MS27512H
w/AMENDMENT 1
27 June 2025
SUPERSEDING
MS27512H
12 May 2015

DETAIL SPECIFICATION SHEET

CONNECTORS, ELECTRICAL, CIRCULAR, NUT, HEXAGON,
CONNECTOR MOUNTING, FOR MIL-DTL-38999, SERIES II, AND MIL-DTL-27599, SERIES II

FIGURE 1. Nut, hexagon.

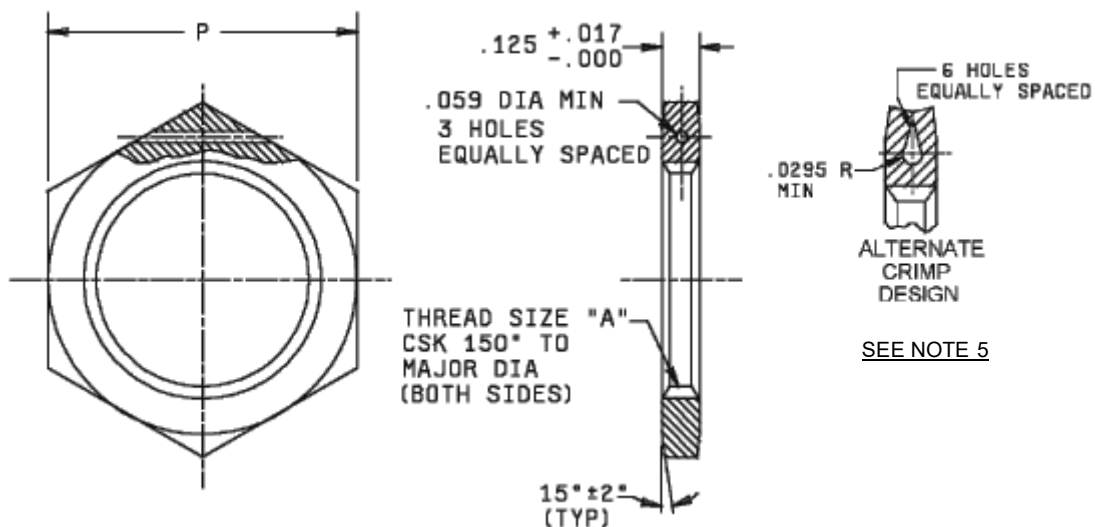
1. Dimensions are in inches.
2. Metric equivalents are given for information only.
3. Threads shall be in accordance with MIL-S-7742.
4. Remove all burrs and sharp edges.
5. Standard safety wire holes are drilled. The safety wire openings depicted in the alternate design are crimped. The alternate hex nut with a crimped edge is specified by adding “-C” to the Part or Identifying Number (PIN).
